FIRST FLOOR VENTILATION
NEW WORK

2007 REMODEL
HANSON OFFICE BUILDING
SPRINGFIELD, ILLINOIS

M1.2V

FIRST FLOOR PLAN - NEW WORK

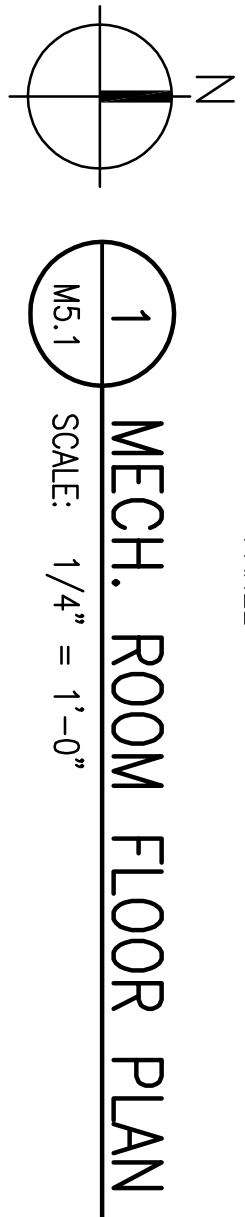
5 VAV Boxes are circled.
(North, South, East,
West, exterior edge of
the building. And 1
interior box as well.)
